ADDENDUM NO. 1

March 19, 2025

School District of Haverford Township | Coopertown Elementary School Renovations & Additions
CRA Project No. 3758

PROJECT
3758

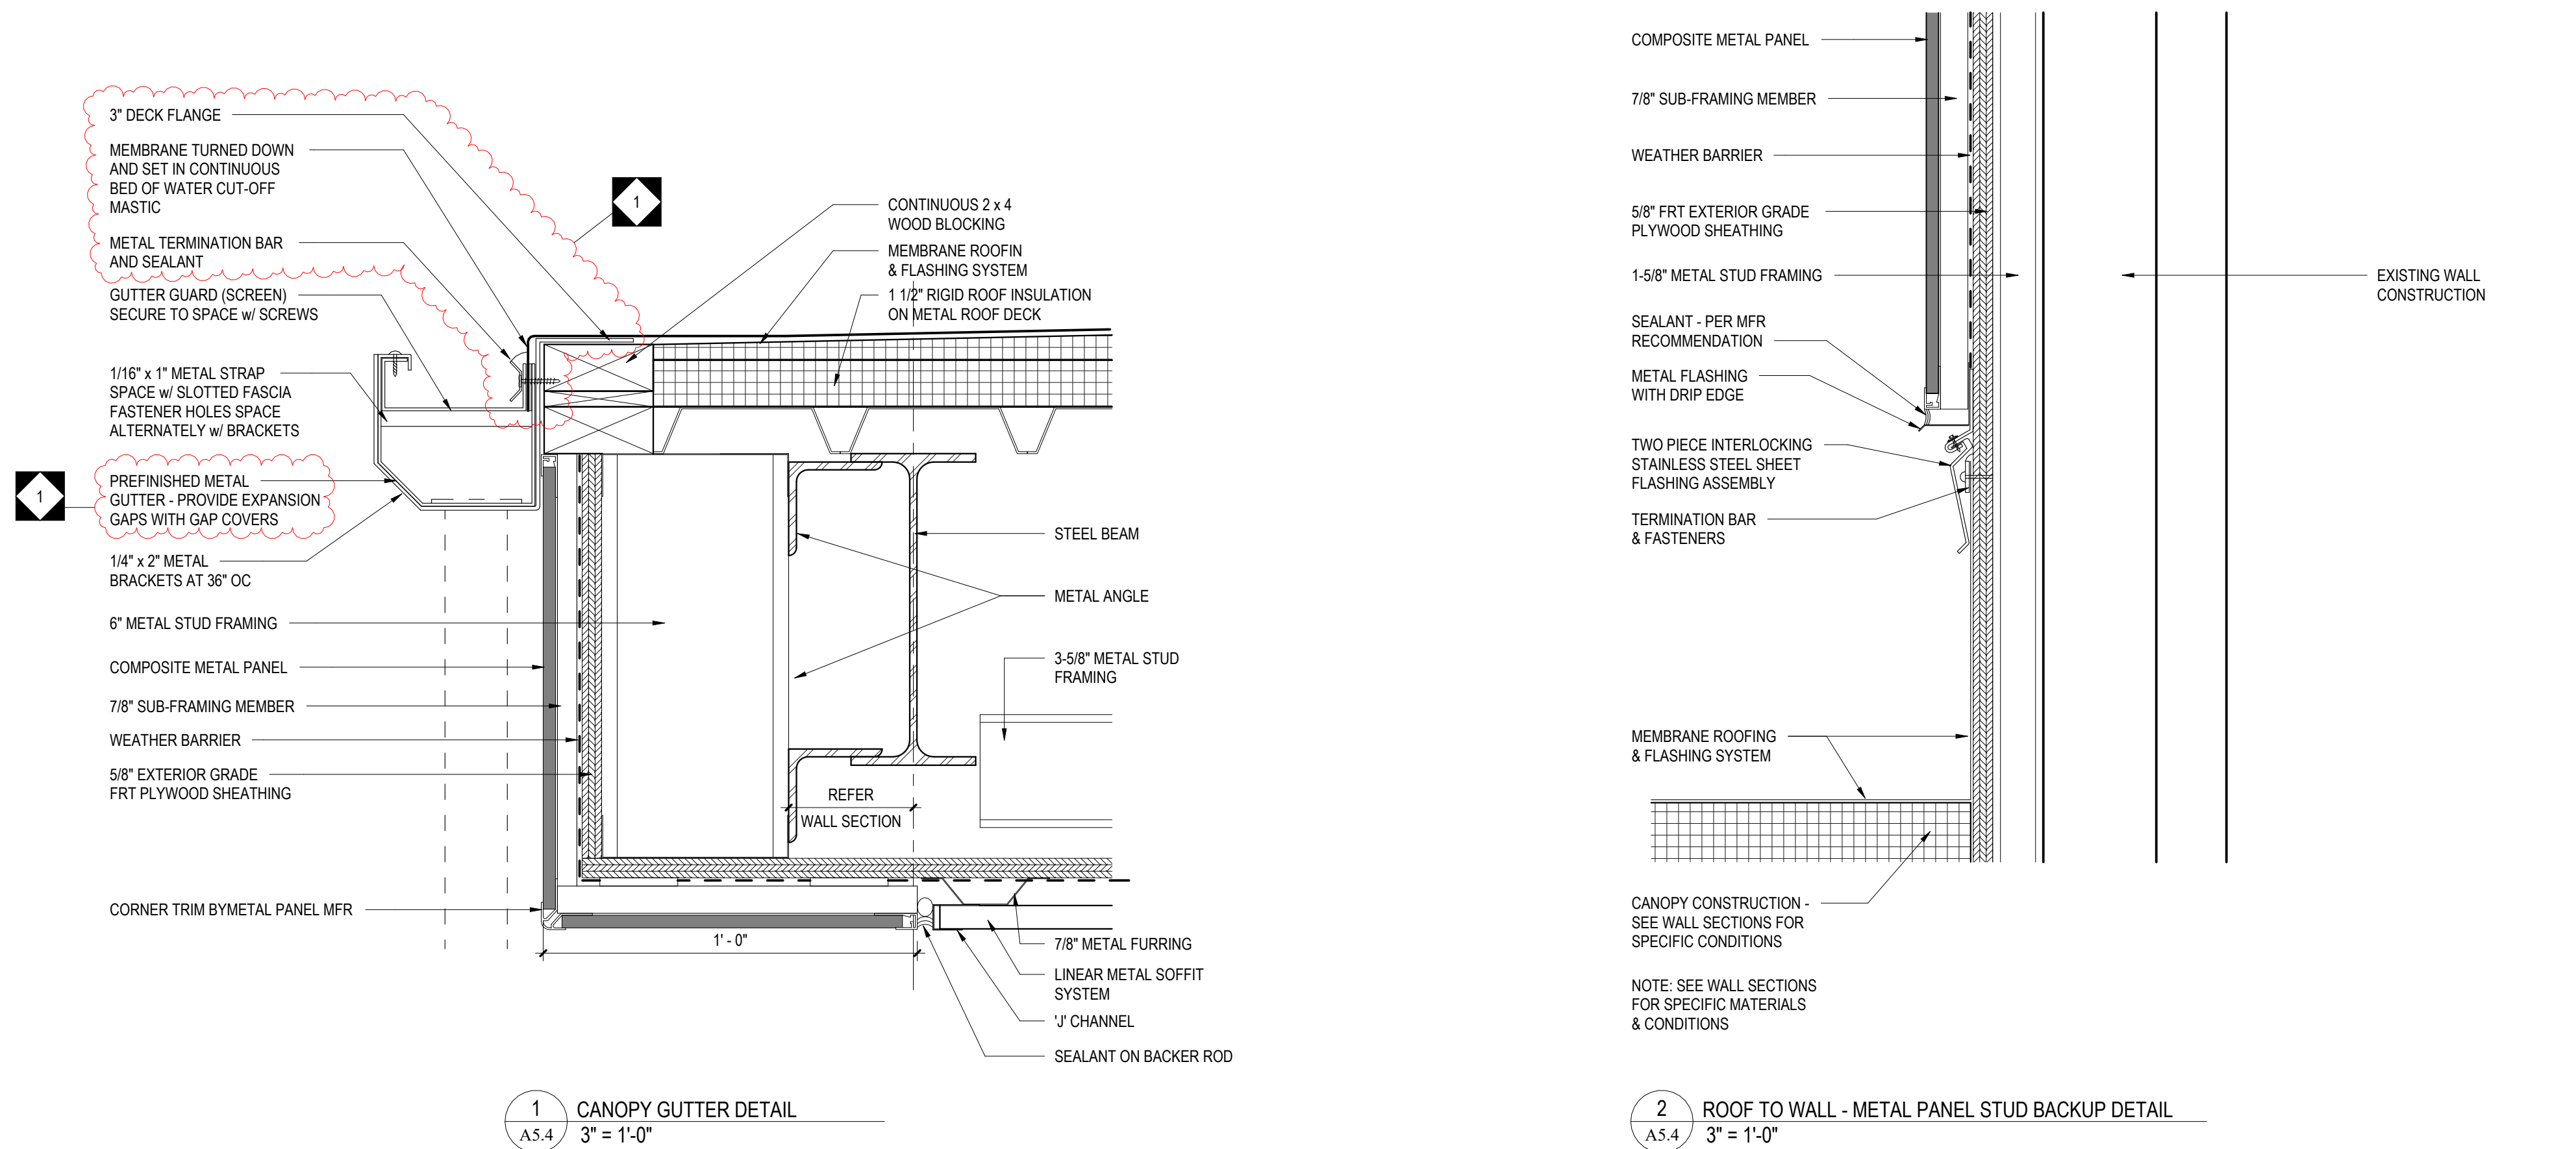
1. DELETE - Detail 3/A5.3
2. 1/A5.3
 - a. REVISE - Standing seam interior gutter detail changed from stainless steel liner to 60 mil EPDM liner
3. 2/A5.3
 - a. REVISE - Nailbase changed to 3-½" insulation and sub-framing depth updated to be 2" matching annotation
4. REVISE - Annotation inconsistencies clarified

M1.2

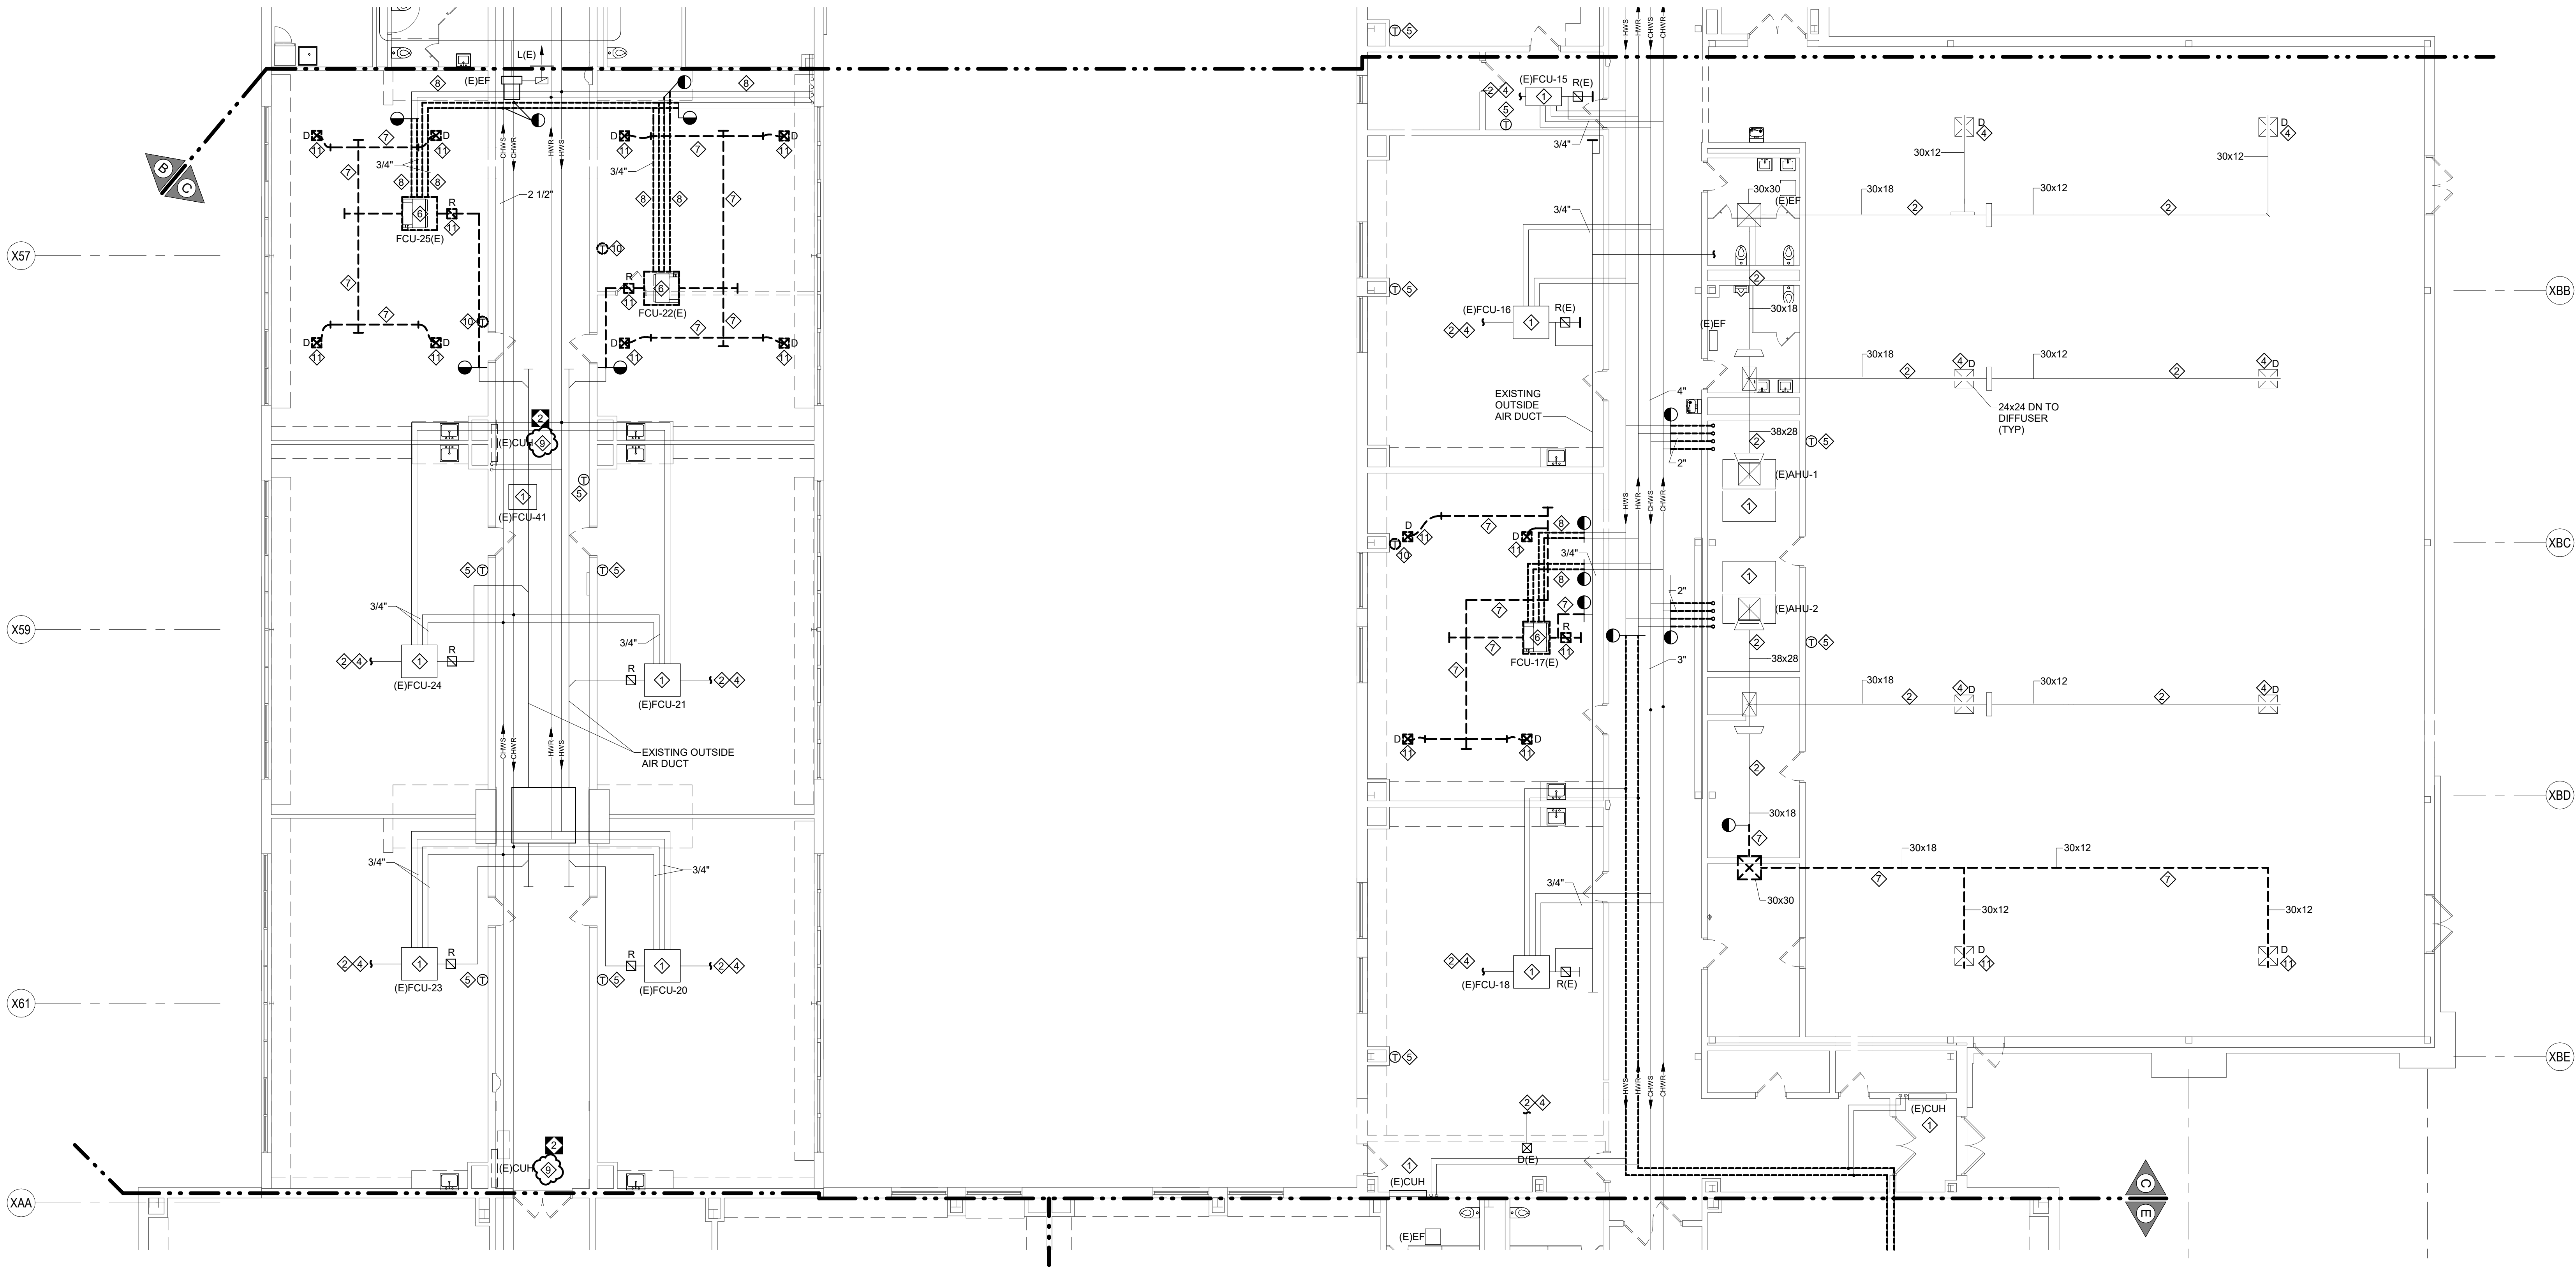
1. **DELETE** drawing note no. 14, in Toilet room A124. Drawing note moved to drawing M1.1.

FIRST FLOOR UNIT B HVAC

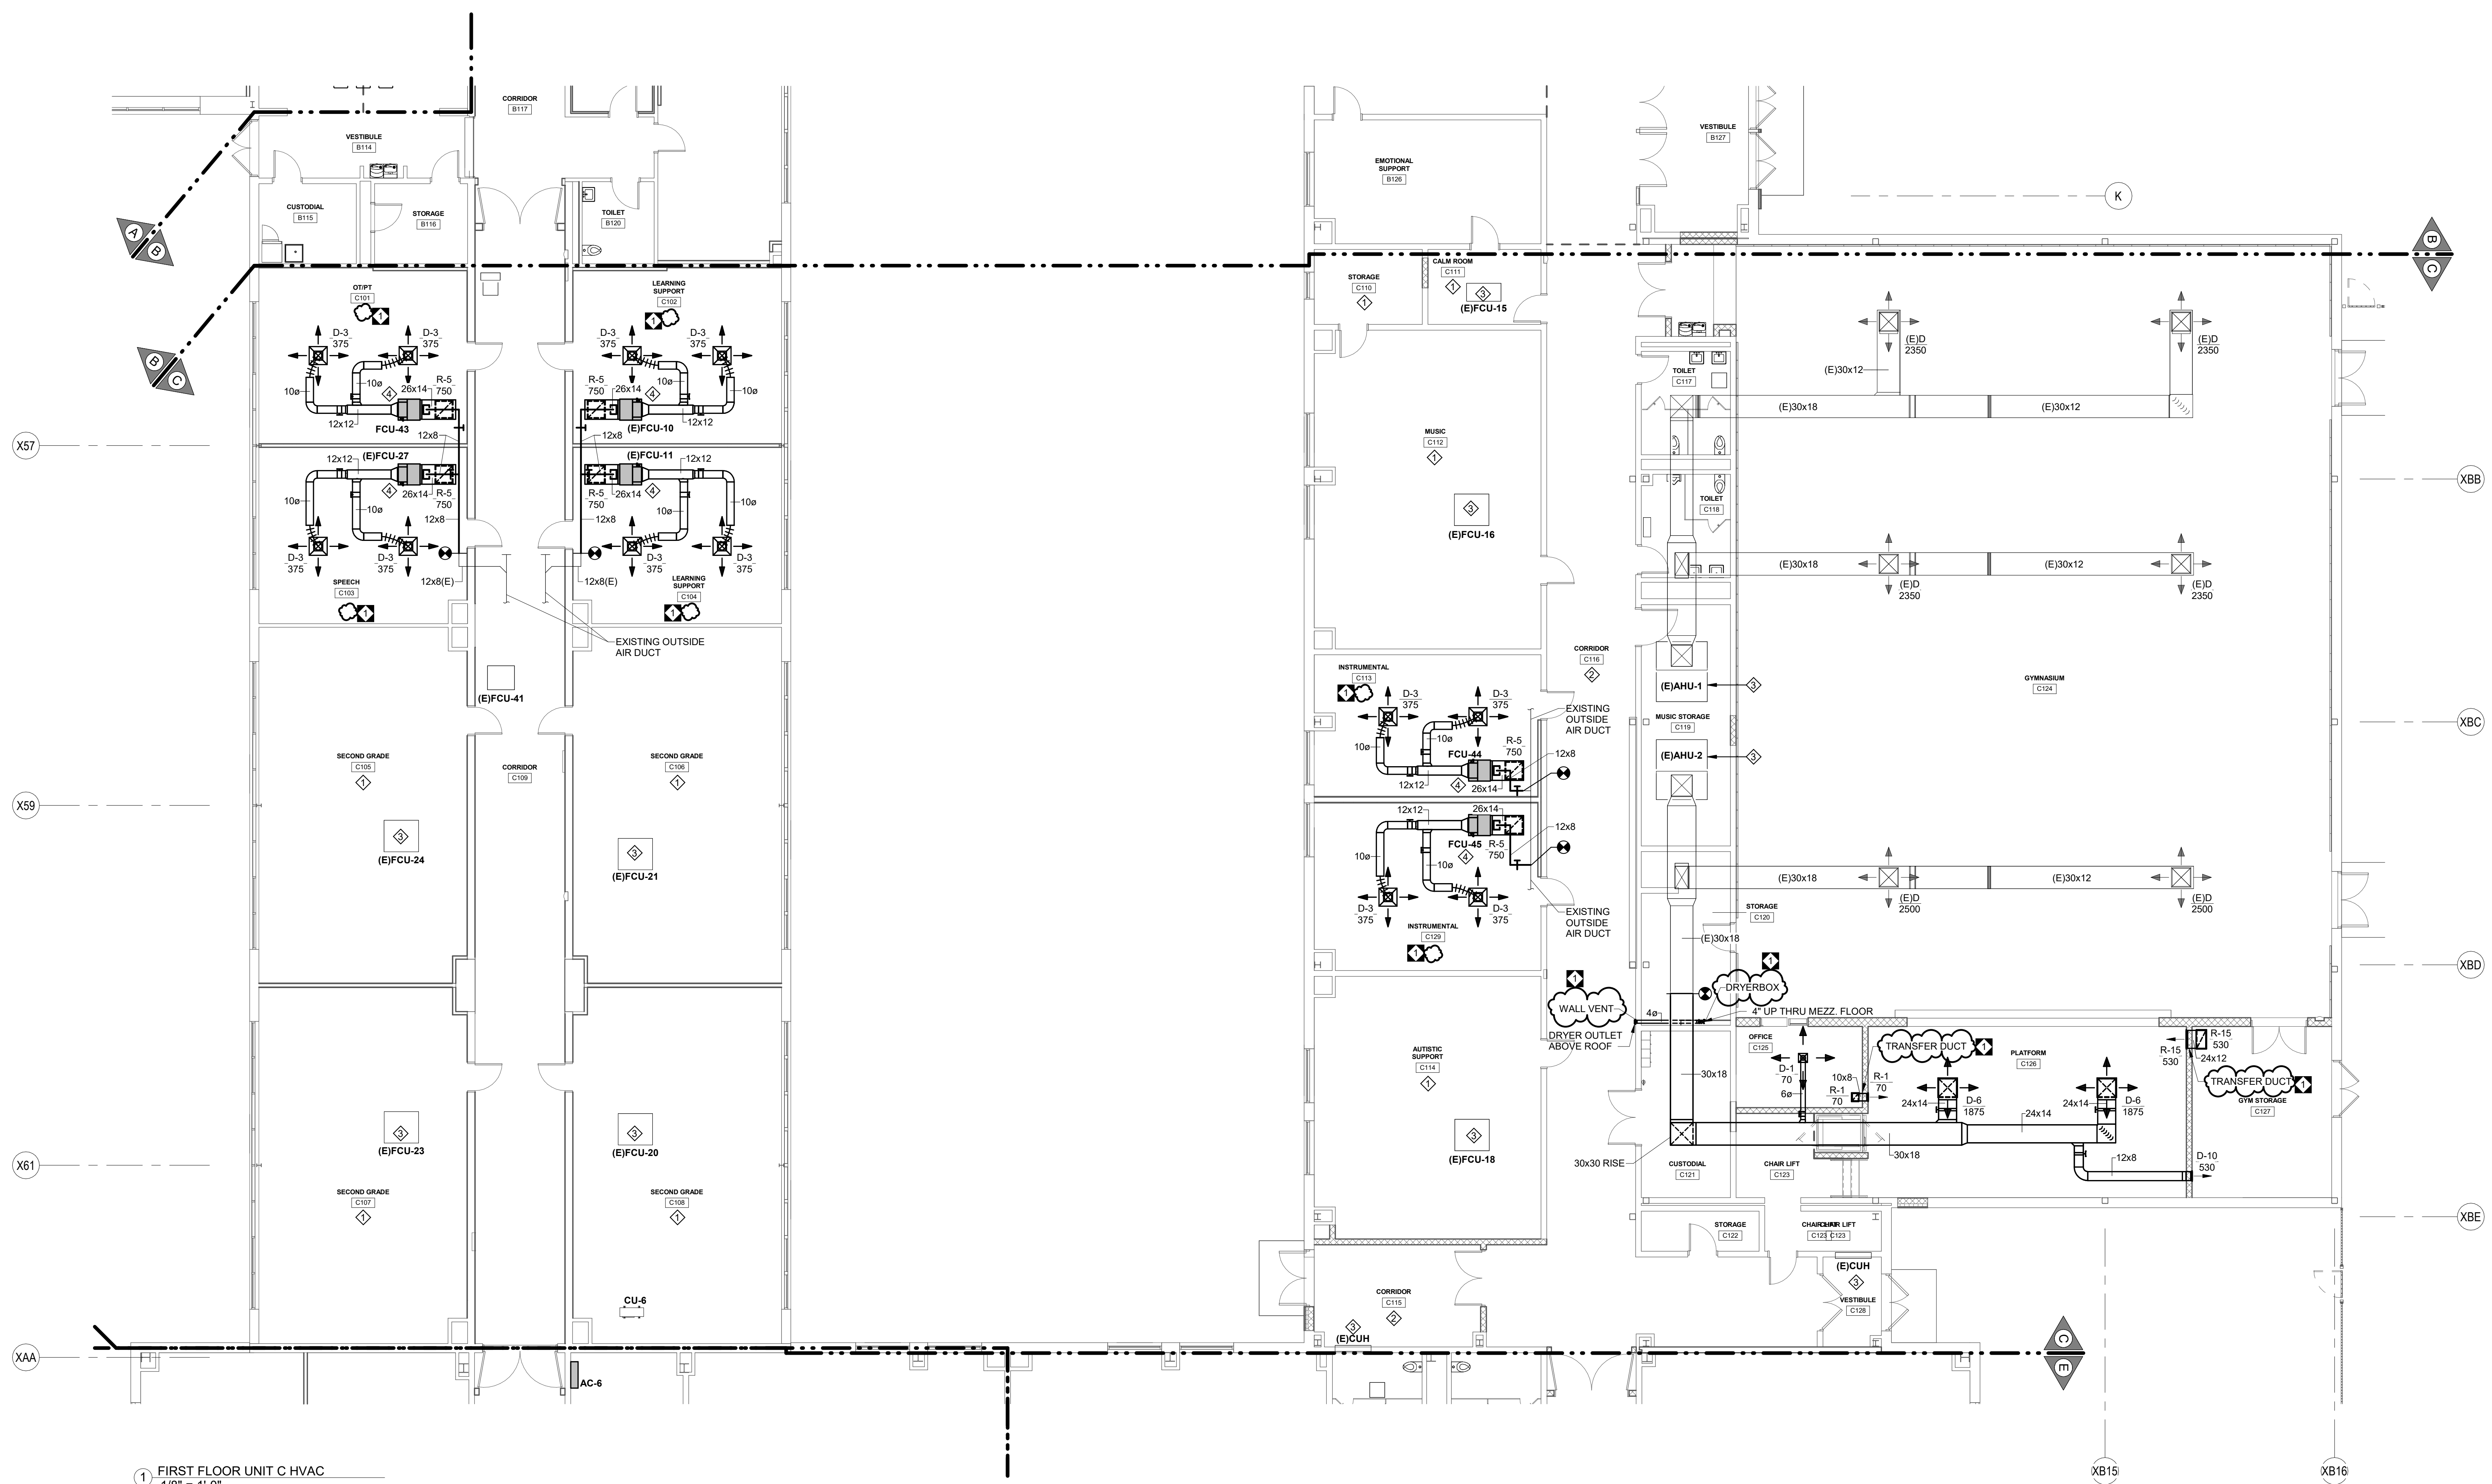
1. **ADD** to drawing note no. 1 “ARCHITECT REPLACING ACT TILE ON EXISTING ACT GRID. HVAC DIFFUSERS AND REGISTERS TO REMAIN. **CLEAN AIR DEVICES.**”
2. **DELETE** drawing note no. 2 and associated tags on the plan.
